CITY OF CAMBRIDGE, MASSACHUSETTS

PLANNING BOARD

NOTICE OF DECISION

Case Number:	293
Address:	79 JFK Street
Zoning:	Residence C-3 / Harvard-Radcliffe-Lesley Institutional Use Overlay District
Applicant:	President and Fellows of Harvard College, c/o Harvard Planning & Project Management 1350 Massachusetts Avenue, Suite 573, Cambridge, MA 02138
Owner:	President and Fellows of Harvard College Massachusetts Hall, Cambridge, MA 02138
Application Date:	August 5, 2014
Date of Planning Board Public Hearing:	October 7, 2014 and continued to November 25, 2014
Date of Planning Board Decision:	November 25, 2014
Date of Filing Planning Board Decision:	January , 2015
Application:	Request for Project Review Special Permit (Section 19.20) to permit the construction of three institutional building additions and redevelopment of the courtyard at the Harvard Kennedy School Campus.
Decision:	GRANTED, with Conditions

GATEWAY BUILDING - ALTERNATE PROPOSAL

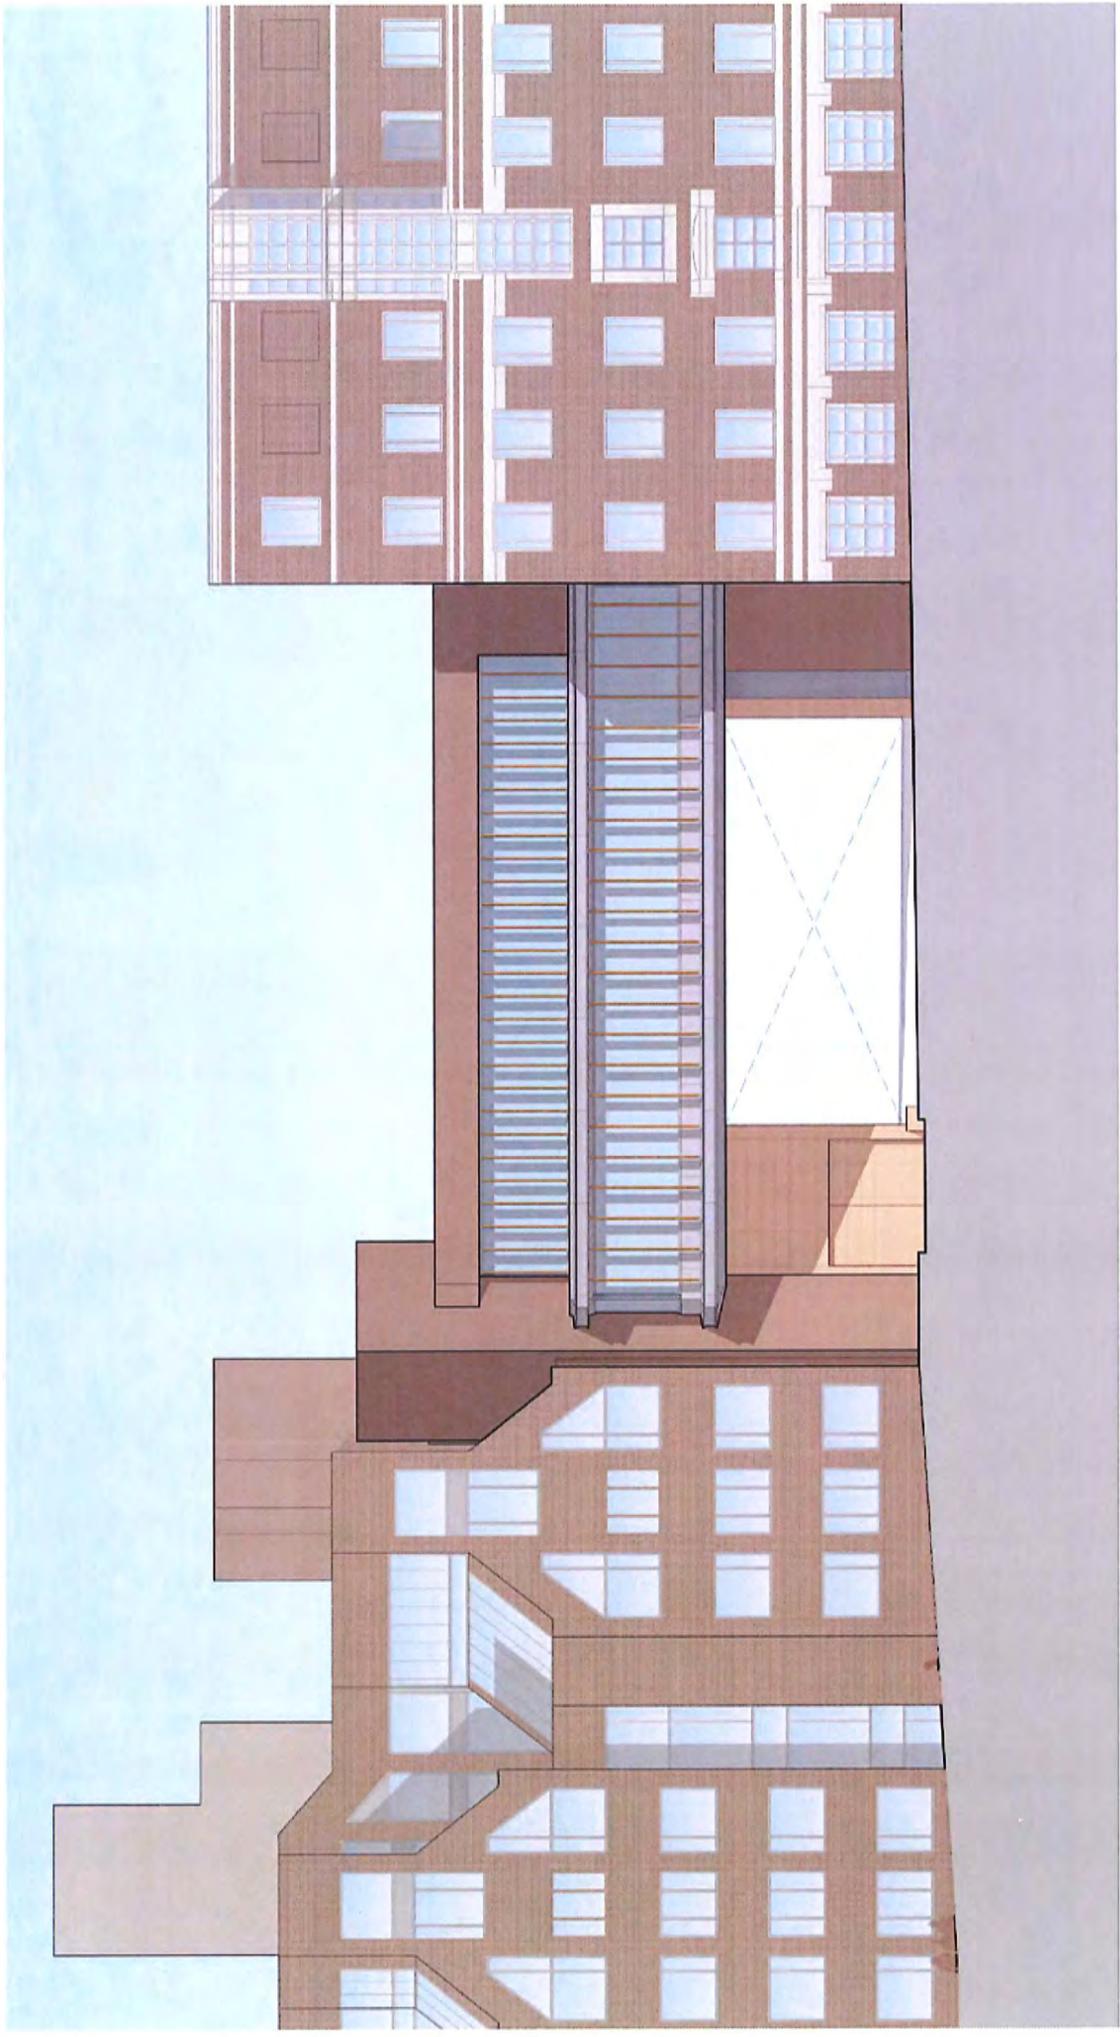
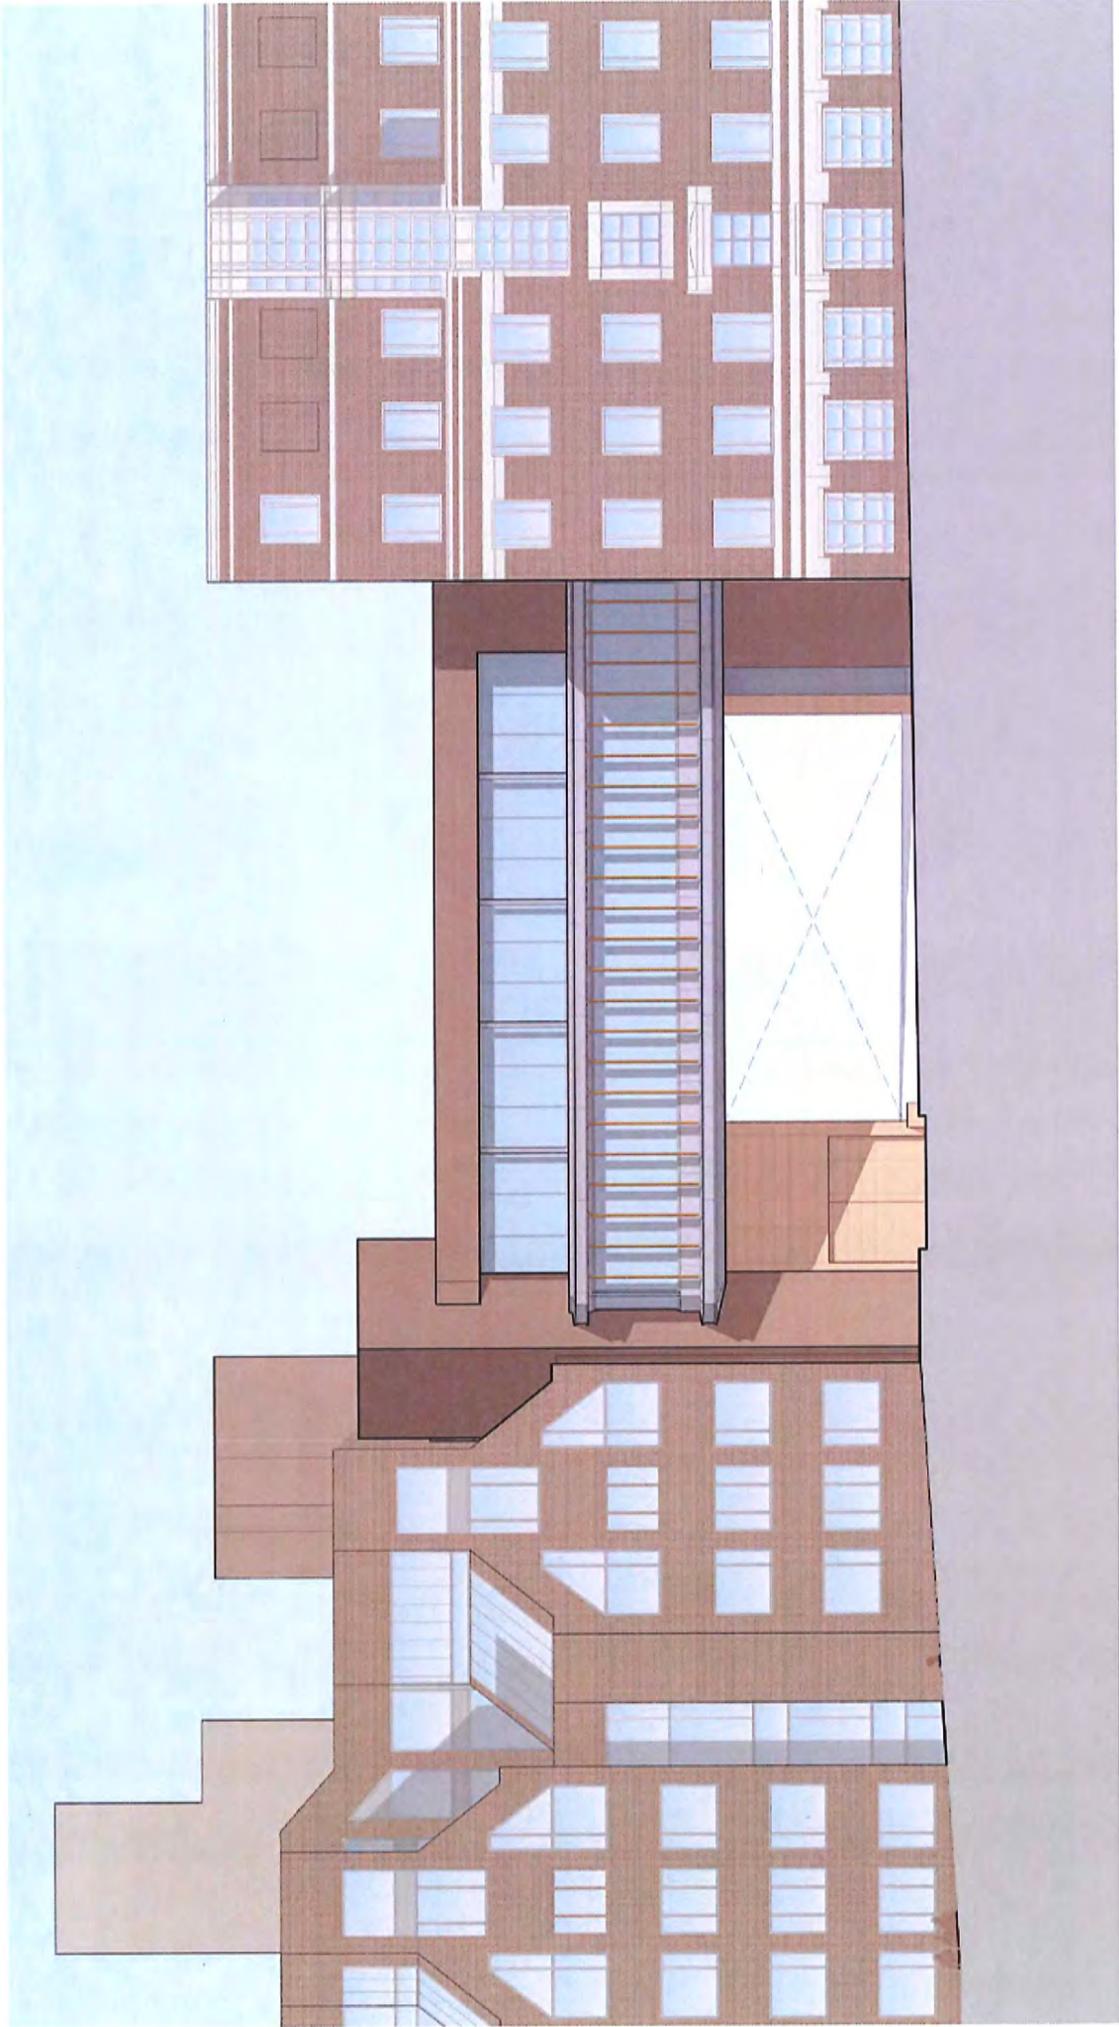
In response to comments at previous the public hearings, the design team has continued to study the façade treatment of the Gateway and West buildings and is proposing further modifications of their articulation. In order to diminish the verticality of these facades the spacing of "fins" on the lower levels of both buildings has been expanded to 3' - 4" (from 2' - 6" in the West Building), in addition this detail is no longer being proposed for the upper level of the Gateway Building. (See Attachment 3-3; 3-5)

WEST BUILDING ELEVATION - 3'-0" HEIGHT REDUCTION

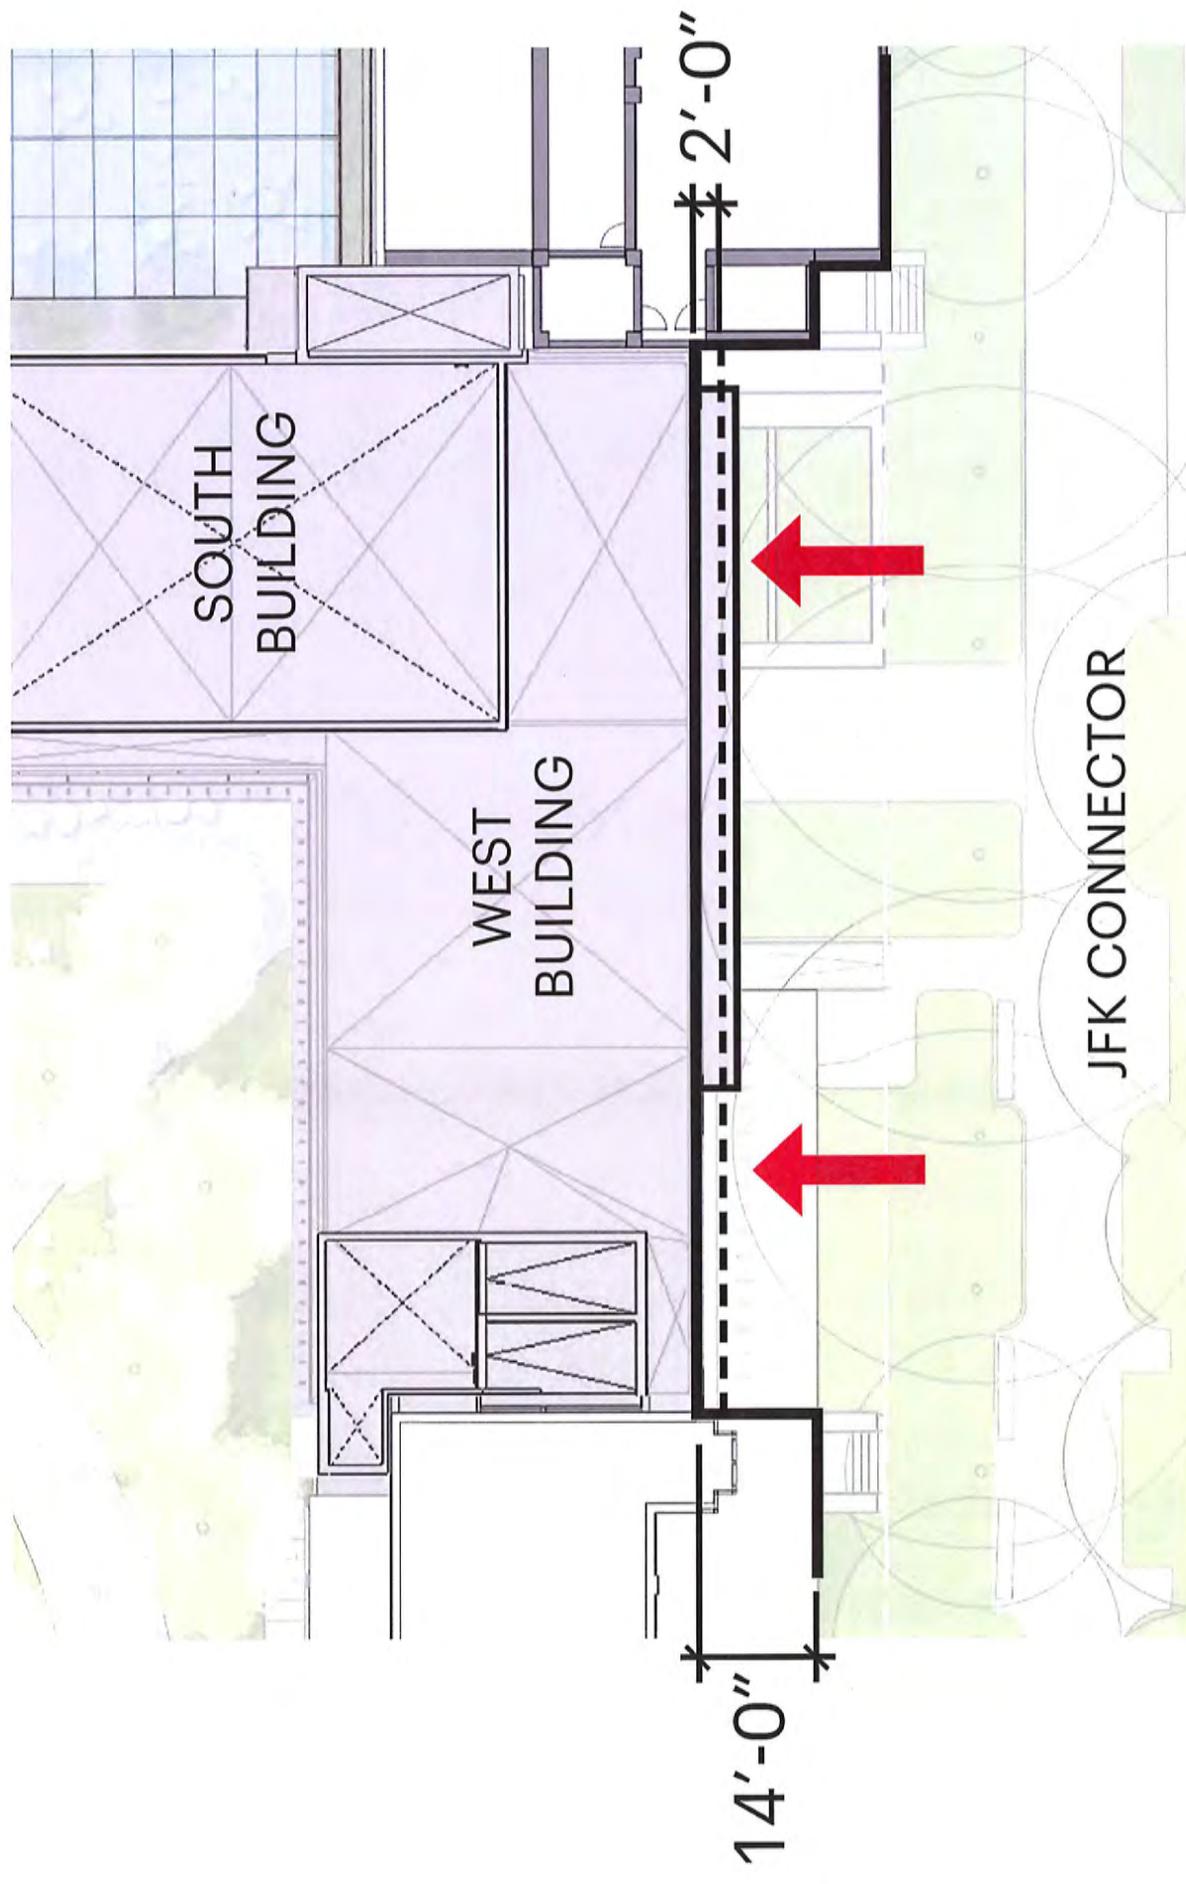
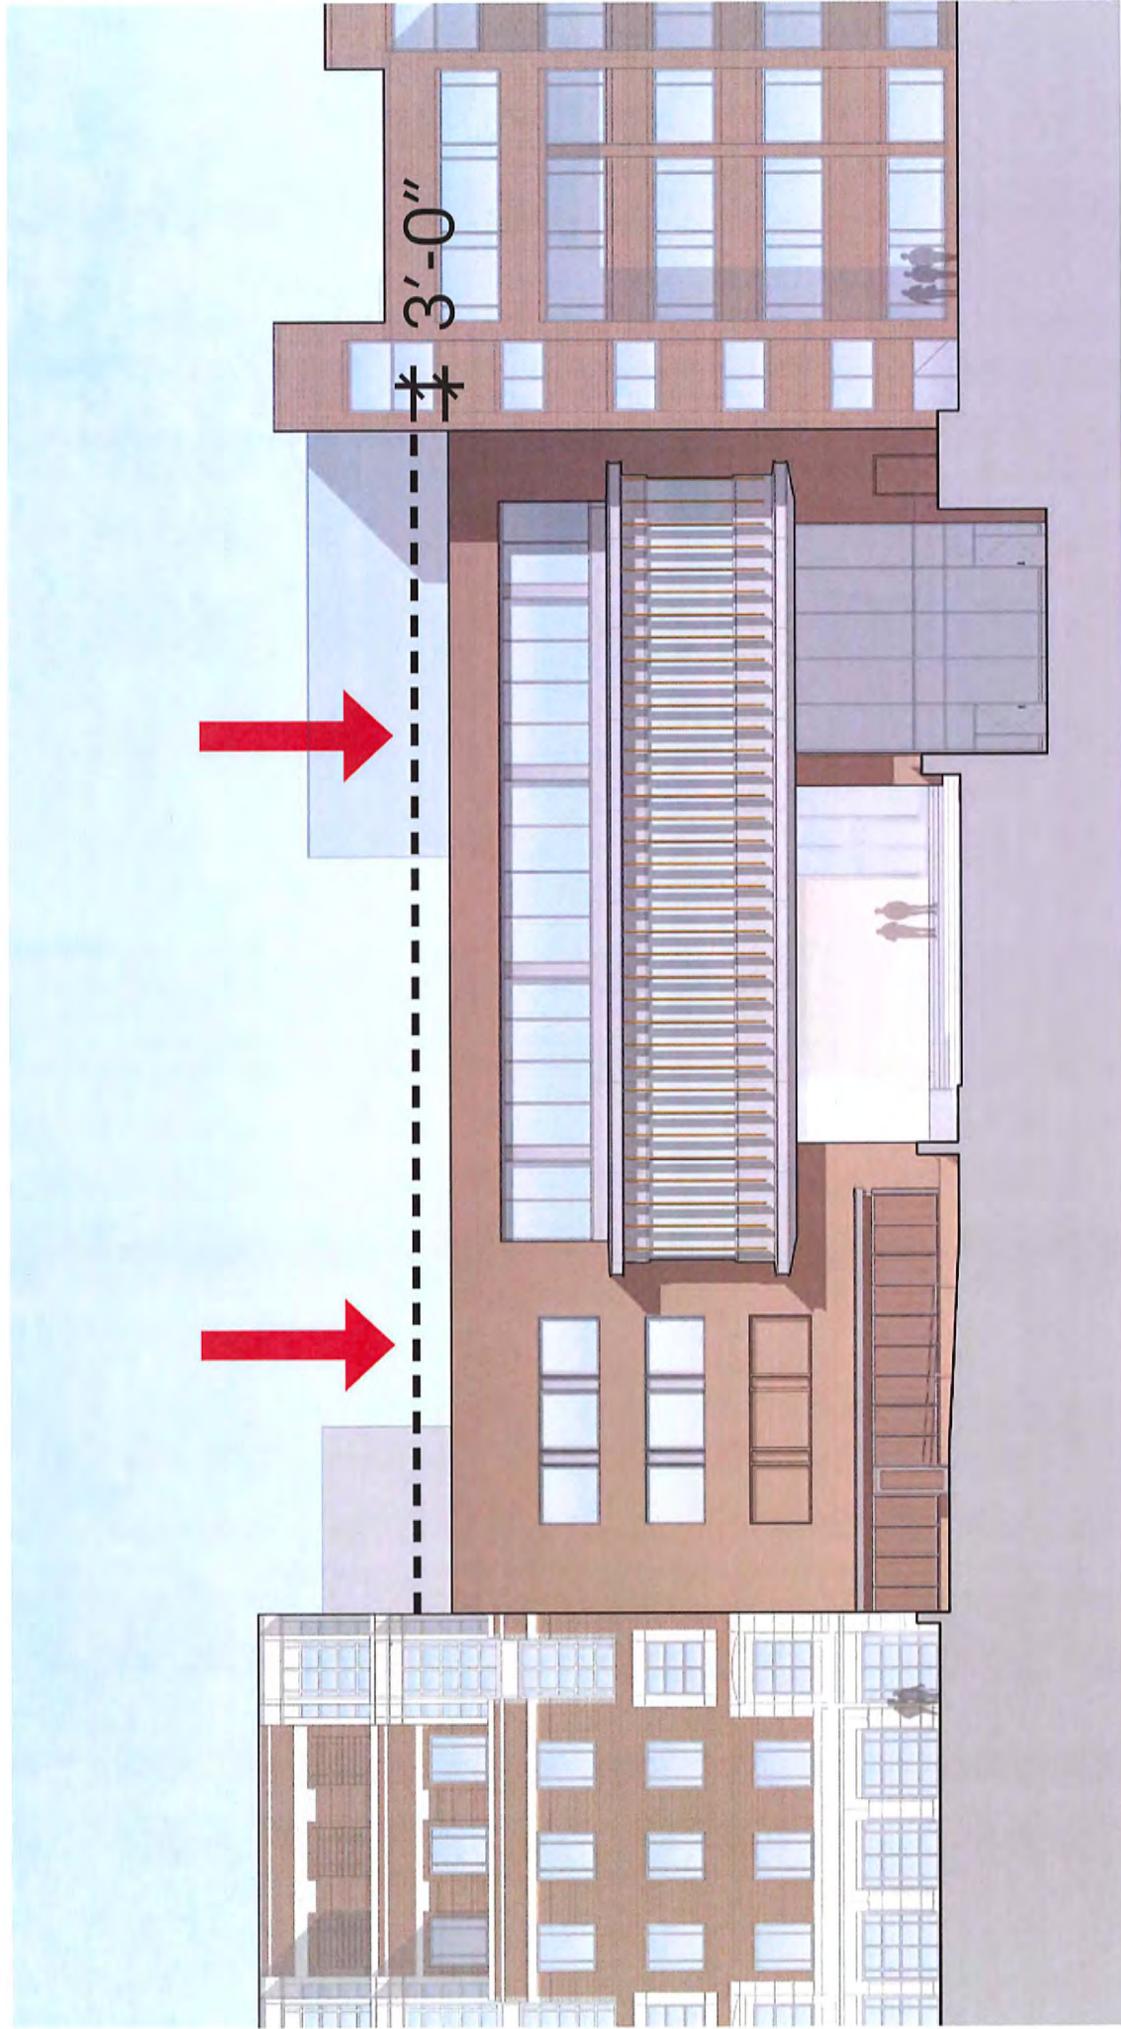
Second, the height of the West Building has been reduced by three feet (See Attachment 4-3). This change is in addition to the previous modification that moves the mechanical penthouse back from the façade a total of 24 feet. These changes will further reduce the visual presence of this addition along the pedestrian walkway. Also, as previously noted, the spacing of the "fins" on the lower level has been expanded to 3' - 4" (from 2' - 6") consistent with the detailing of the Gateway Building (See Attachment 4-5).
